Monterey Bay Engineers, Inc.

Re: Proposed Resolution Nos. R3-208-0060 and R3-208-0061
192 and 194 San Remo Road, Carmel Highlands, CA
Monterey County PLN 060251, Combined Development Permit Application
Monterey County PLN 040050, Combined Development & Lot Line Adjustment
Current Monterey County Assessor Parcels 243-181-005 and 243-181-006

Item No. 26 Attachment No. 4
WDR Moeller Residence
194 San Remo Rd.
R3-2008-0061
December 4-5 2008 Meeting

Enclosure: Copy of Assessor's Map Book 243, Page 18

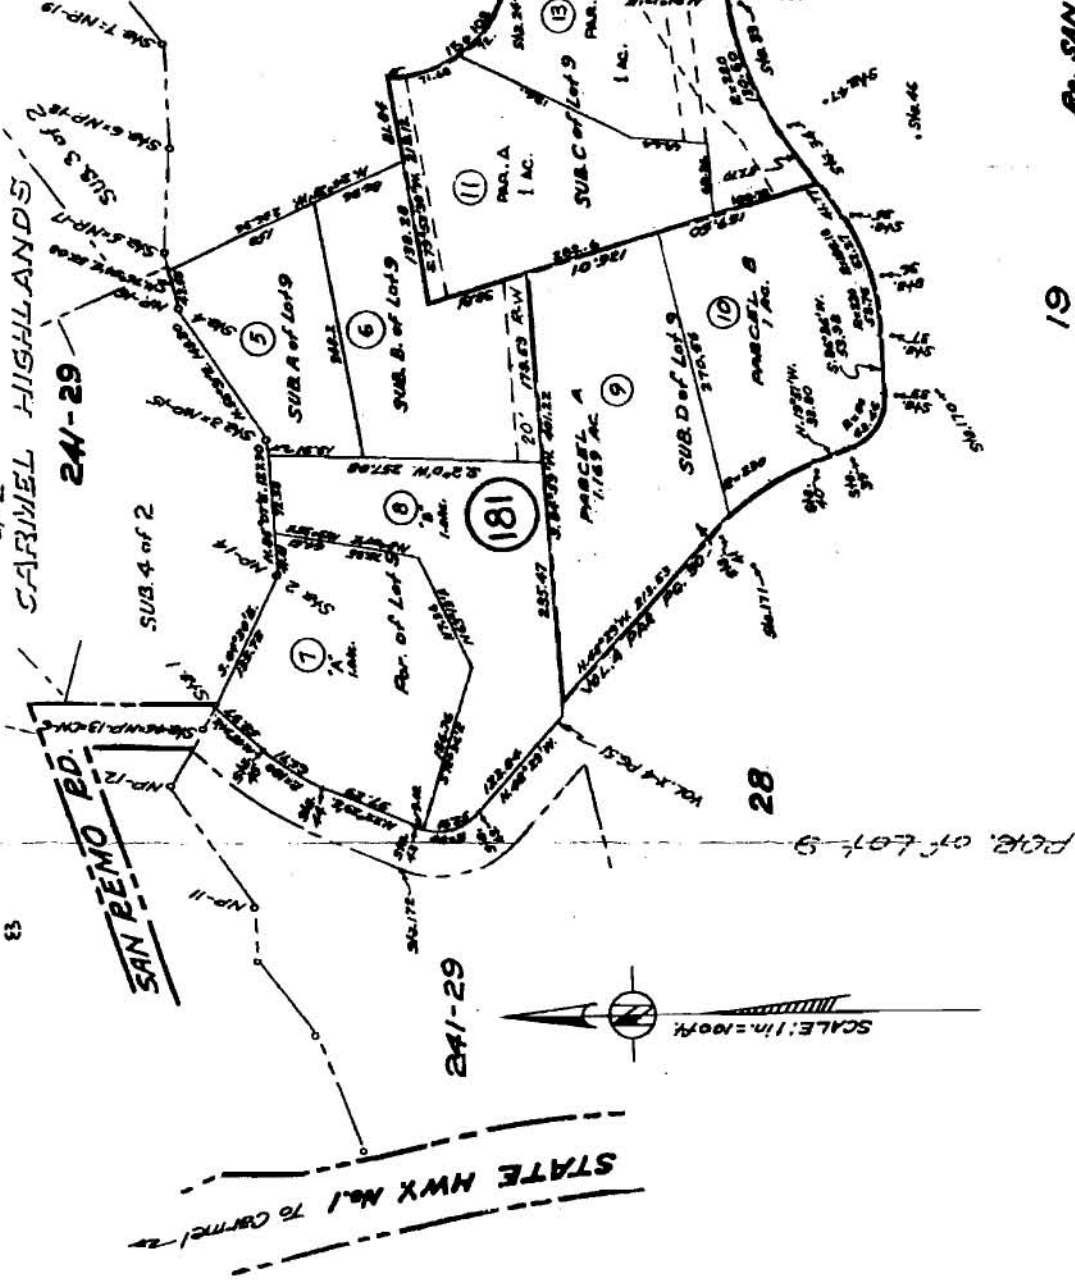
Enclosed is a copy of the current Monterey County Assessor's map showing the configuration of the existing parcels. While it may be more efficient from your agency's viewpoint to approve both

of these parcels simultaneously, you must recognize that the parcel boundaries (and hence the setbacks and entire site plan) are based on a boundary configuration that does not exist, and may never be approved. It would seem most reasonable for the applicant to pursue the approval of an advanced wastewater system only after the basic parameters of the site are factual.
